ADDENDUM

ADDENDUM NO.: 07
PROJECT NAME: Emergency Medical Services (EMS) Addition
PROJECT NO.: 07215
CONTRACT NO.: C1611
DATE OF ISSUE: August 7, 2024

1. S101 – SECOND FLOOR FOUNDATION PLAN, dated 08/07/2024

SHEET TITLE
SECOND FLOOR FOUNDATION PLAN

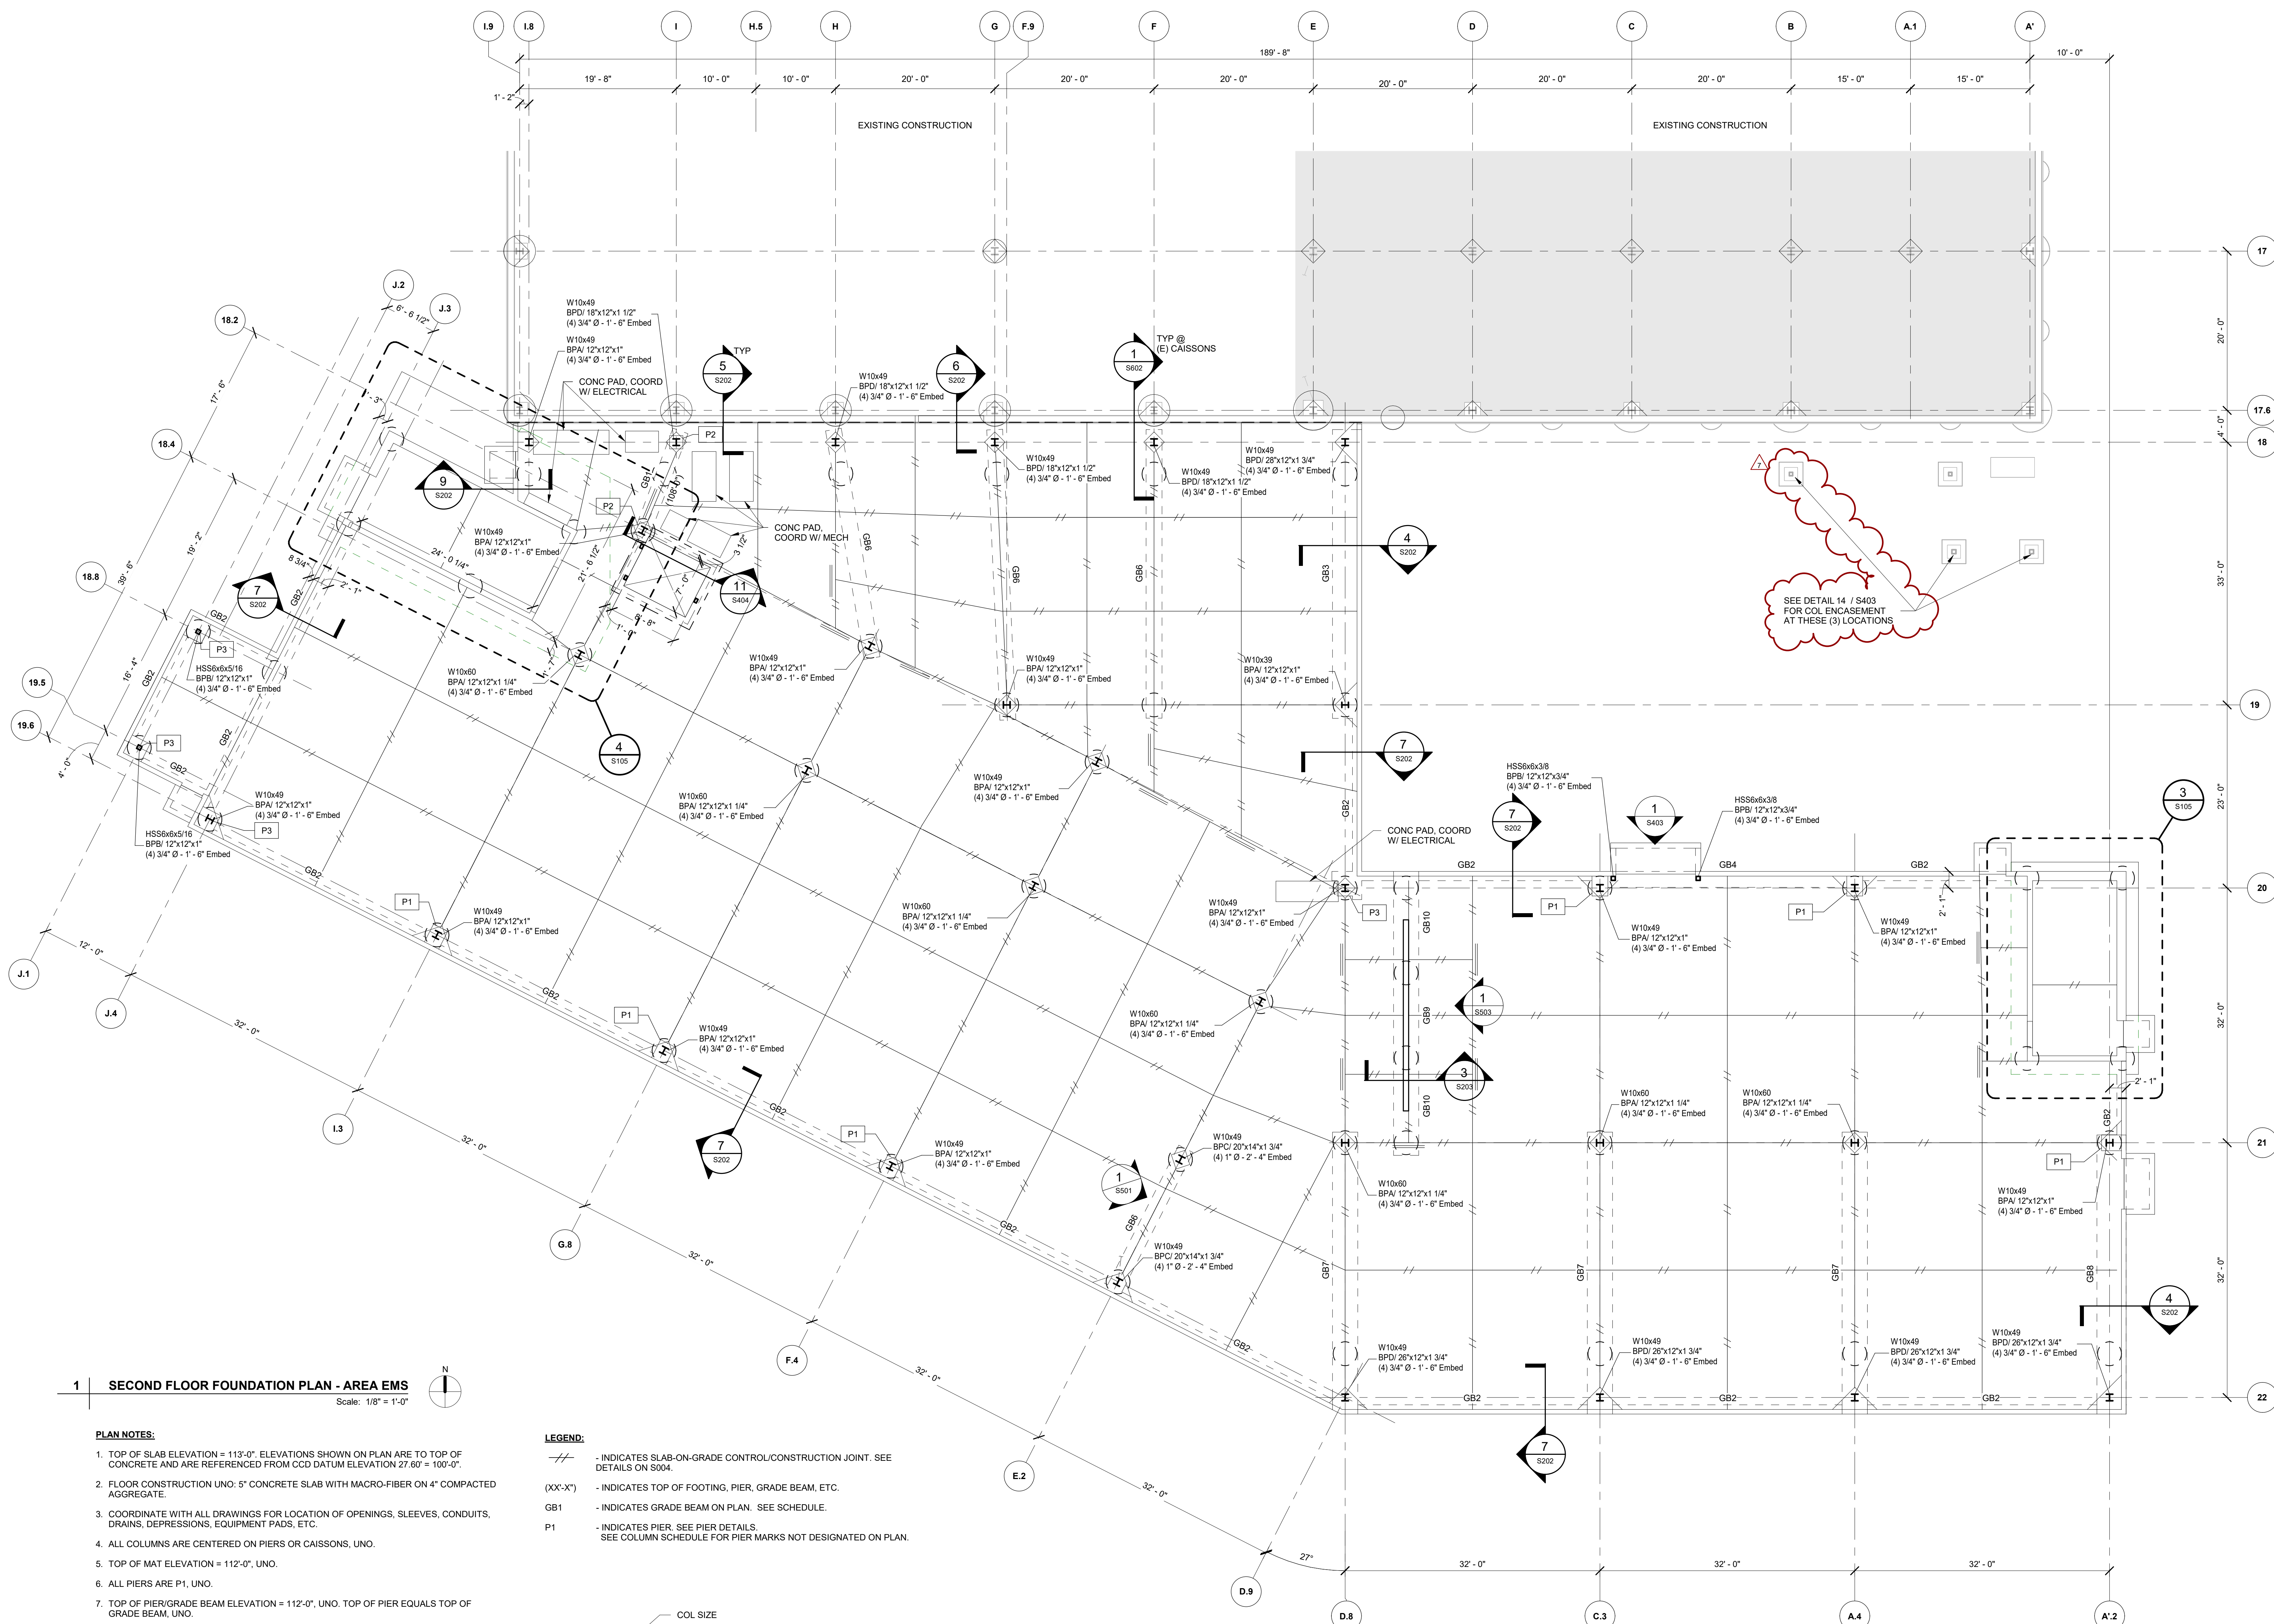
- ITEM NO. 1: CHANGE TO KEY DATES**
None.
- ITEM NO. 2: REVISIONS TO BOOK 1 – PBC INSTRUCTIONS TO BIDDERS**
None.
- ITEM NO. 3: REVISIONS TO BOOK 2 – PBC STANDARD TERMS AND CONDITIONS**
None.
- ITEM NO. 4: REVISIONS TO BOOK 3 – TECHNICAL SPECIFICATIONS**
None.
- ITEM NO. 5: REVISIONS TO DRAWINGS**
Change 1 REVISED Drawing No. S101 – Updated reference and detail regarding column encasement at three (3) locations.
- ITEM NO. 6: REQUESTS FOR INFORMATION**
None.
